February 6, 1991
5000-91-2012
C320-91-2003

Subject: Oyster Creek Nuclear Generating Station
Docket No. 50-219
Response to Request for Additional Information
Instrument Setpoints

FIGURE 1
REO2 (REACTOR LO-LO LEVEL ES ACTUATION)
INSTRUMENT LOOP SETPOINT DIAGRAM
(AT OPERATING CONDITIONS)

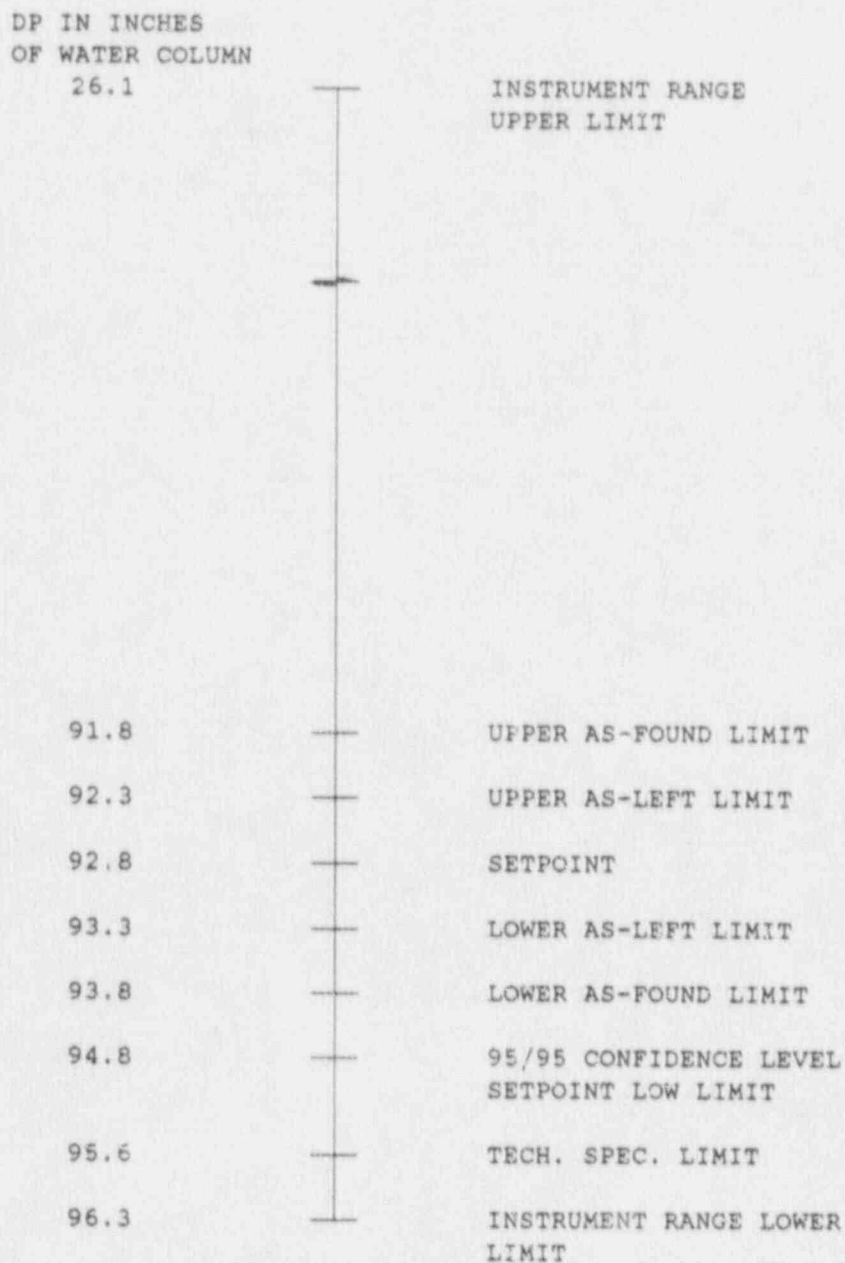
The Staff requests that GPU Nuclear show that the setpoints for instrument loops RE-02 A, B, C and D and RE-18 A, B, C and D are sufficiently above instrument zero so the margin between instrument zero and the actuation point is greater than the historical or calculated instrument accuracy.

The attached Figures 1 and 2 show setpoint and range related values for the instrument loops in question. The figures show that the setpoint is sufficiently above instrument zero such that the instrument will actuate within its specified range. The other thirty seven Technical Specification instrument loops discussed in Reference 2 were reviewed and their setpoints, including calibration tolerance and drift, are within the range of the instrument.
